Report under 10CFR21 of noncompliance

- N7030 temperature transmitter (all sub-models)

Engineering Bulletin for N7030 and N7040 Temperature Transmitters

The current technical bulletin contains updates to the technical specifications of the N7030 and N7040 transmitters and field fixes for issues identified the N7030 transmitter.

Figure 1

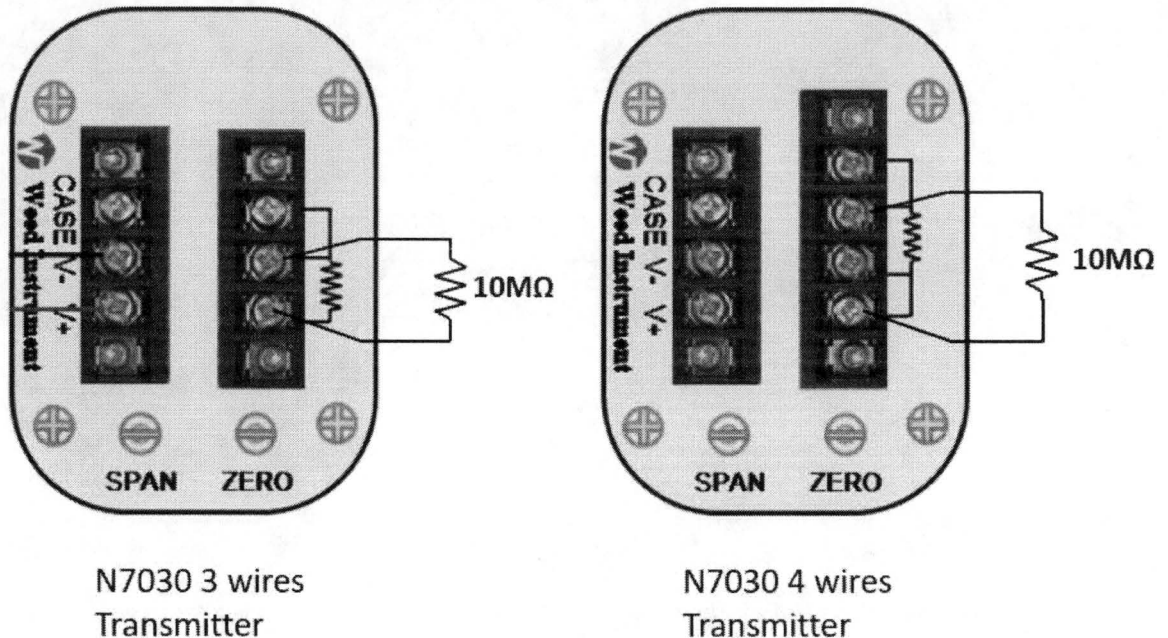
N7030 may fail to detect some failures on RTD sensor or sensor wiring

Affected models: N7030 (RTD input)

Conditions: The sensor error detection may fail when two wires are interrupted or when RTD sensor and one connection wire are interrupted at the same time.

Recommended fix: Connect an external resistor between the transmitter terminals as described below.

Resistor value: 10MΩ
 Manufacturer: Vishay-Dale
 Resistor PN: RN55D1005FB14

- Cut the resistor terminals 3/4" long
- Bend the resistor leads keeping 3/4" between them for the 4 wire RTD transmitter and variant and 3/8" for the 3 wire RTD variant.
- Identify the connection terminals depending on the transmitter model – see Figure 1. Pay attention to the connection points. Connecting the resistor to the wrong terminals will not restore the fault detection function.

- Power down the transmitter. The rework could be performed with the transmitter powered ON, but it will output erratic values that could affect the control loop.
- Unscrew the connector terminals and insert the resistor leads near the connection wires
- Tighten back the connector screw terminals.
- Bent the resistor such that the resistor body or the leads will stay away from the transmitter case and from the RTD connection wires

Note: The added 10MΩ resistor will add negligible measurement error. The transmitter doesn't need to be recalibrated after this procedure.
